STAFF RECOMMENDATION
1012 Main Street, 1004 Forrest Avenue
October 16, 2019

Application: New Construction-Infill
District: Lockeland Springs-East End Neighborhood Conservation Zoning Overlay
Council District: 06
Base Zoning: MUG-A, CS
Map and Parcel Number: 08309013200, 08309013100
Applicant: Manley Seale, Architect
Project Lead: Sean Alexander, sean.alexander@nashville.gov

Figure 1: Photo from Forrest Ave. and Main Street

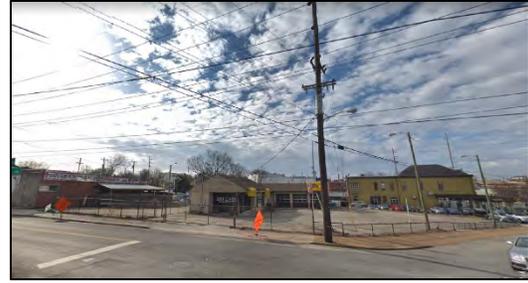
Background: The two parcels at the southeast corner of Main Street and Forrest Avenue in East Nashville are currently vacant.

Most recently, the properties were the site of a used car lot where a non-contributing building stood. The building was demolished earlier this year.

ELEVATIONS - HISTORICAL

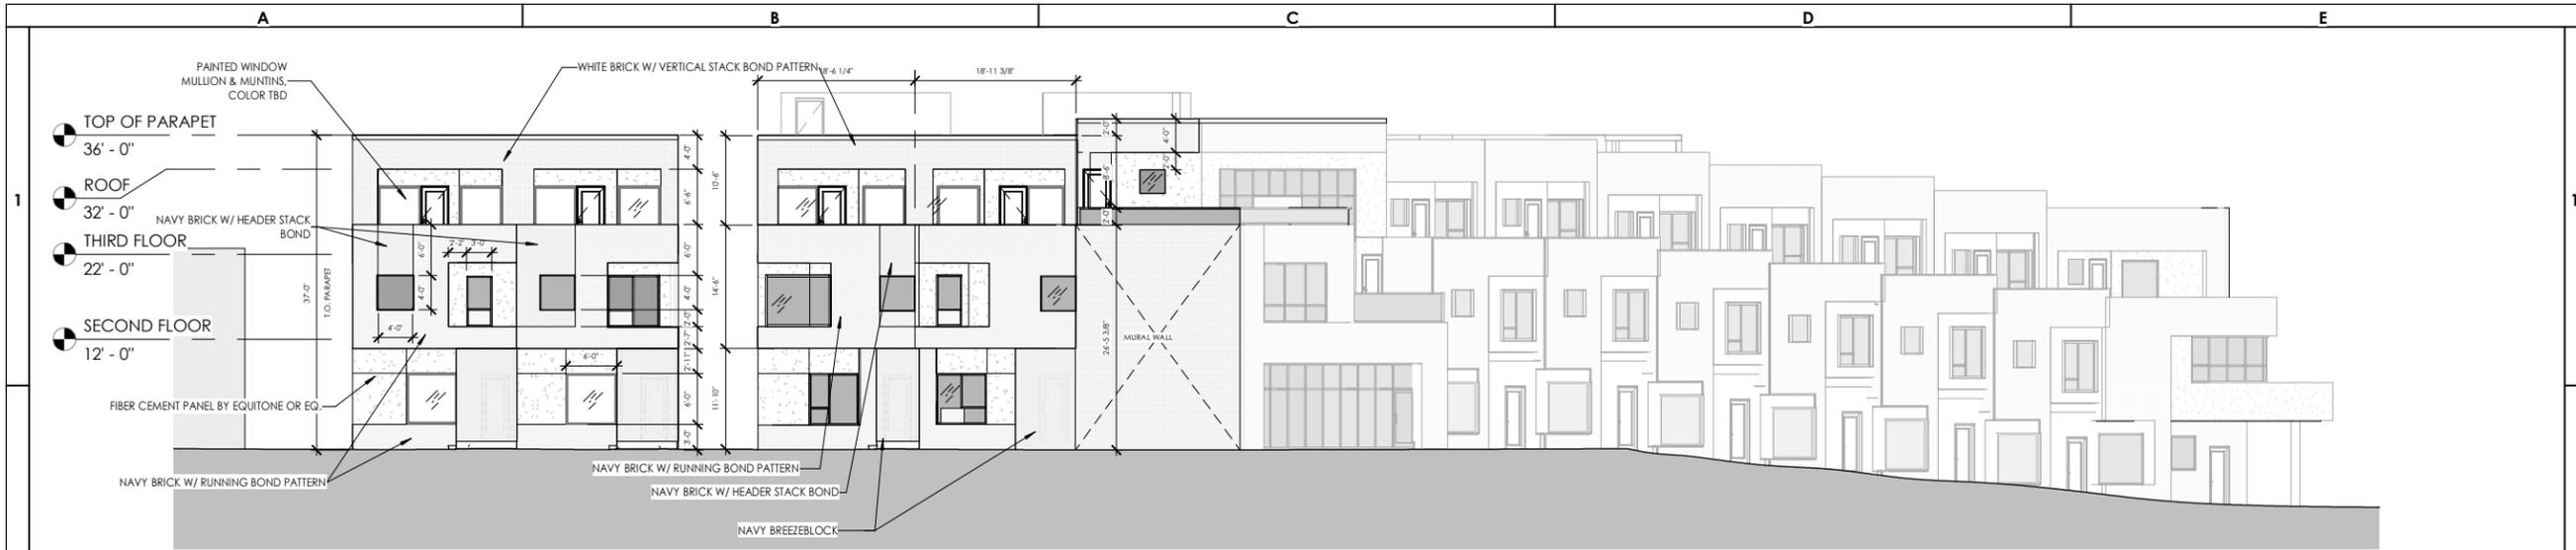
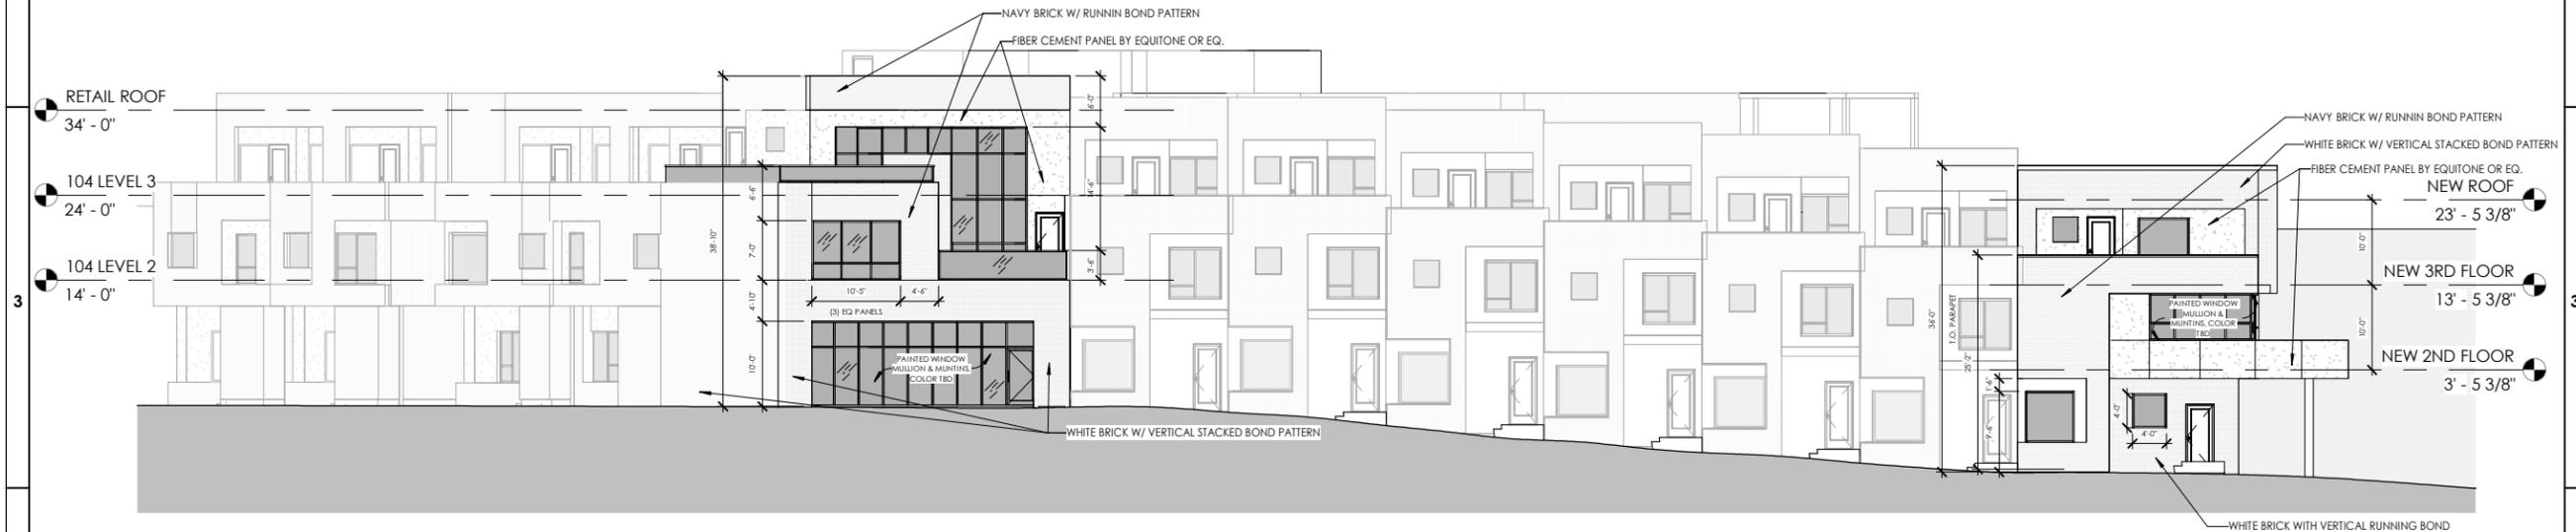
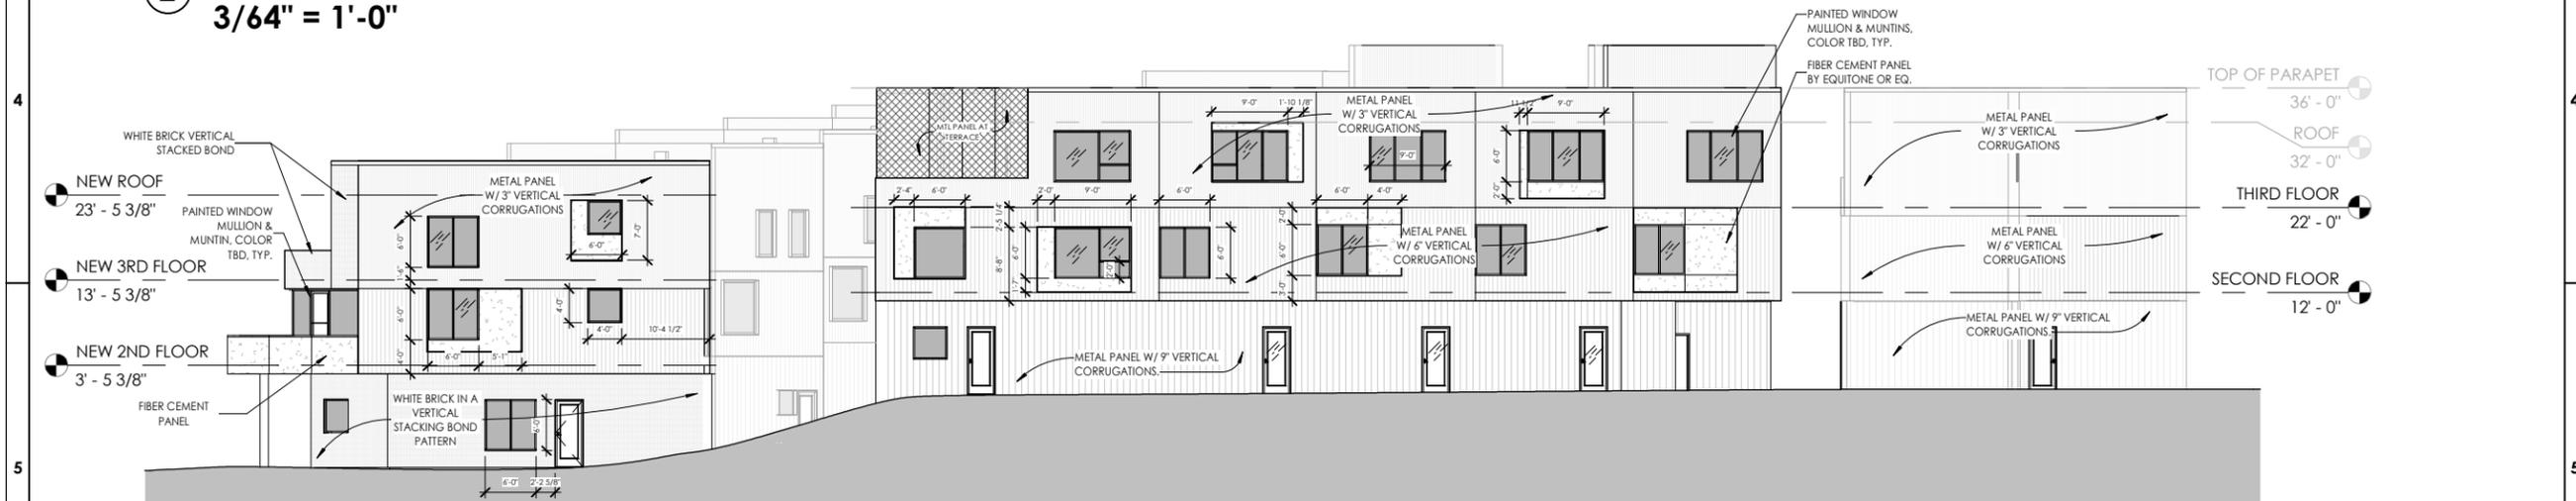
The plans show a glass railing at the top of the corner commercial component for uncovered patio spaces. There is no historic precedent for glass extending above the parapet of a primary wall. Continuing the parapet up in brick would be more appropriate, and more typical of the historic commercial buildings in the Five Points area. This would also result in a wall height of eighteen feet (18'), closer to meeting the guideline that walls shall be a minimum of twenty feet (20') tall.

The plans also show that metal siding will be used on the rear of the street-fronting buildings and on the courtyard building. Metal siding is not permitted by the design guidelines. Because the metal is only being used on non-street facing elevations, staff finds that it will not have a significant impact on the character or appearance of the project as viewed from the right-of-way.

No windows or doors are proposed on the Forrest Avenue façade of the corner component. The design guidelines require first story commercial spaces on corners to

have glazing turning the corner and continuing a minimum of twenty feet (20'), and that upperstory façade areas be at least twenty-five percent (25%) windows.

With a condition that windows are added on the Forrest Avenue façade of the corner commercial component, the first and second stories, Staff finds the project's proportion and rhythm of openings to meet Section II.B.7. of the design guidelines

1. The parapets on the corner commercial component shall be brick instead of glass;
2. The masonry selections shall be approved by MHZC staff;
3. Brick shall be a historic red brick color;
4. The window and door selections are administratively approved; and
5. Windows and/or doors shall be added on the Forrest Avenue façade of the corner commercial component on the first and second stories.
